MINUTES

Planning Committee

Tuesday, 7 May 2024 at 6:30 PM

12.2	2 PARKER STREET - NEW RESIDENCE	6
12.5	28A STATON ROAD - NEW DWELLING	29
12.1	16 PIER STREET - NEW RESIDENCE	46
12.3	83 DALGETY STREET - ALTERATIONS AND ADDITIONS	91

Figure 2.1 Over height portion of building shown in yellow

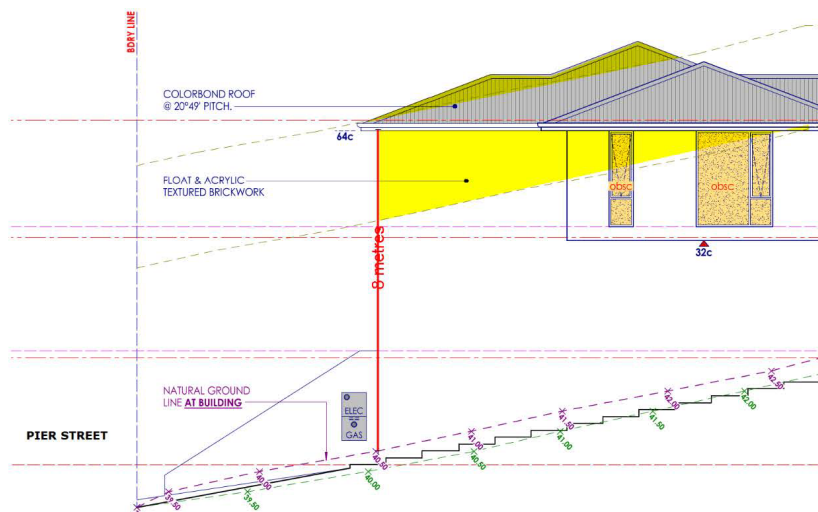
- The portions of building which exceed the required 5.6m wall and 8.1m roof height are highlighted in **Figure 2.1**. The extent of the over height wall and roof height will result in significant bulk and scale on the streetscape and will result in a significantly detrimental impact on the views from the adjoining property towards the river and ocean.

- *The portions of building which exceed the required 5.6m wall and 8.1m roof height are highlighted in Figure 2.1. The extent of the over height wall and roof height will result in significant bulk and scale on the streetscape and will result in a significantly detrimental impact on the views from the adjoining property towards the river and ocean.*
